Work Order ID 87971

Item ID: D4542-7

Item Name: Retainer, Inner

WORK ORDER NON-CONFORMANCE / UPDATE

D4542-7 RETAINER, INNER
(TOP)

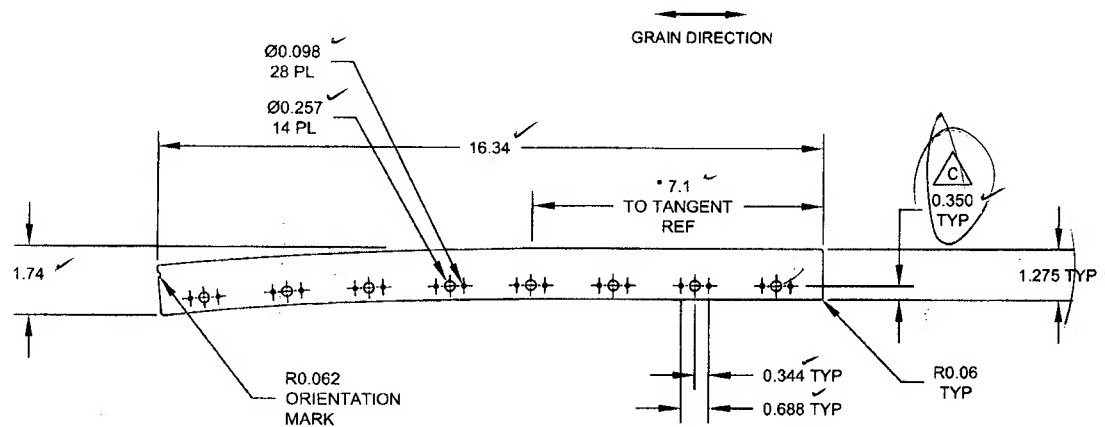
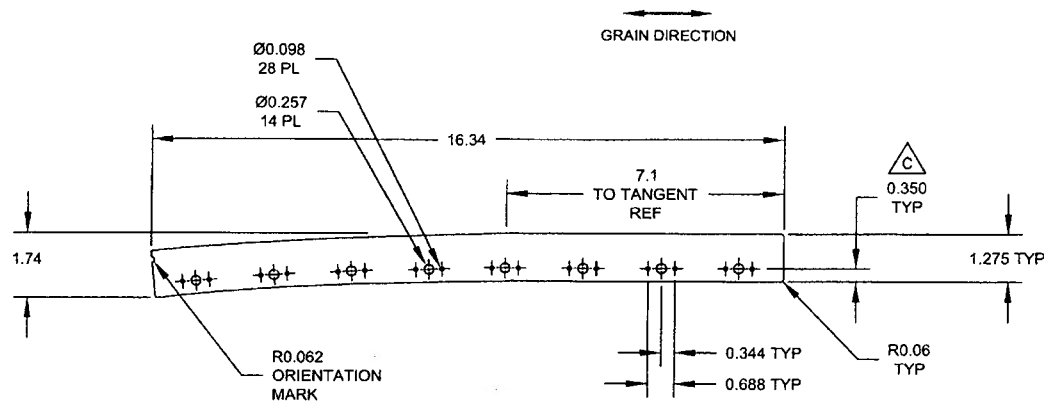
Root Cause	Date	Step	Qty	Description of work order update or Non-conformance	Initial Chief Eng	Action Description	Sign & Date	Verification	QC Inspector
Doc/Data <input checked="" type="checkbox"/>	<u>12/8/13</u>	<u>100</u>	<u>24</u>	<u>1.275 dim is \approx 1.25 in some areas.</u> <u>Reason: dxf file.</u>	 <u>12/8/13</u>	<u>Acceptable.</u> <u>No effect on installation.</u>	 <u>12/8/13</u>	 <u>12/08/13</u>	 <u>12/02/12</u>
Equip/Tooling <input type="checkbox"/>									
Operator <input type="checkbox"/>									
Material <input type="checkbox"/>									
Setup <input type="checkbox"/>									
Other <input type="checkbox"/>									
Process <input type="checkbox"/>									
Supplier <input type="checkbox"/>									
Training <input type="checkbox"/>									
Unapproved <input type="checkbox"/>

Work Order: <u>87971</u>	DISPOSITION Rework <input type="checkbox"/> Scrap <input type="checkbox"/> Use-as-is <input checked="" type="checkbox"/> Work Order Update <input type="checkbox"/>	AGAINST DEPARTMENT/PROCESS			
Part No. <u>D4542-7</u>		Skid-tube <input type="checkbox"/> Machining <input type="checkbox"/> Thermoforming <input type="checkbox"/> Large Fab <input type="checkbox"/>	Crosstube <input checked="" type="checkbox"/> Small Fab <input type="checkbox"/> Finishing <input type="checkbox"/> Composite <input type="checkbox"/>	Water Jet <input type="checkbox"/> Prod. Eng. Coord. <input type="checkbox"/> Rec/Store/Packaging <input type="checkbox"/> Supplier <input type="checkbox"/>	Engineering <input type="checkbox"/> Quality <input type="checkbox"/> Other <input type="checkbox"/>
NCR No. <u>12-1692</u>
